**Environmental
Protection Agency**

RE: MEDINA COUNTY
SILVER CREEK BASIN
CITY OF WADSWORTH
WADSWORTH HIGH SCHOOL
AND COMMUNITY CAMPUS

On July 13, 2010, Ohio EPA conducted an inspection of the Wadsworth High School and Community Campus project, located at 625 Broad Street, City of Wadsworth, Medina County (site). Ohio EPA records indicate that the site is covered by the General National Pollutant Discharge Elimination System (NPDES) Permit for Storm Water Associated with Construction Activity (General Storm Water Permit), permit No. 3GC04539*AG. I was accompanied by Don Husted of Turner Construction Company. The inspection documented the following:

Figure 1. A dandy bag near the construction entrance has been damaged.

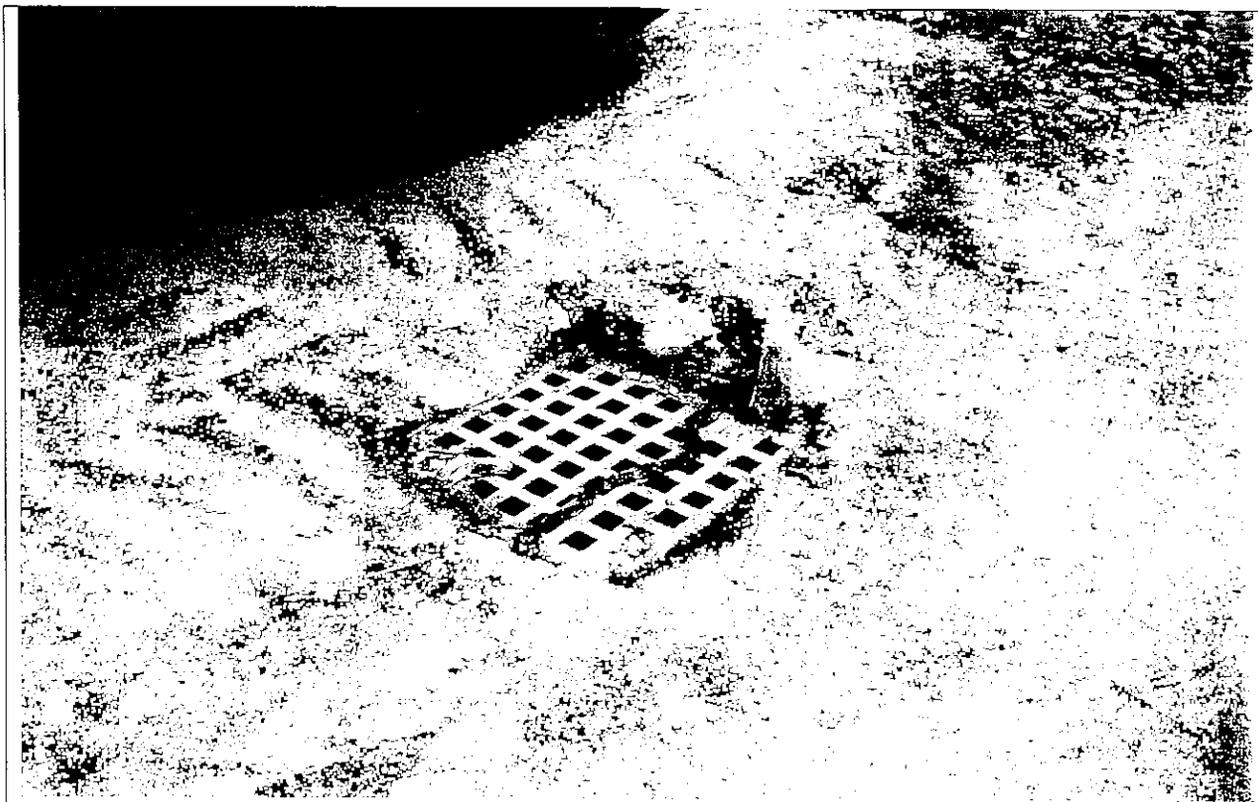
- Inlet protection has been installed on the site's storm sewer inlets. A dandy bag near the construction entrance was observed to be damaged (Figure 1). Replace the dandy bag immediately. Maintain inlet protection in accordance with the site's storm water pollution prevention plan (SWP3).
- Sediment basin #1 was observed to be installed and functioning correctly.
- Currently, construction has been limited to the east end of the site. As earth disturbing activities commence throughout the remainder of the site, ensure that all erosion and sediment controls are installed per the site's SWP3.
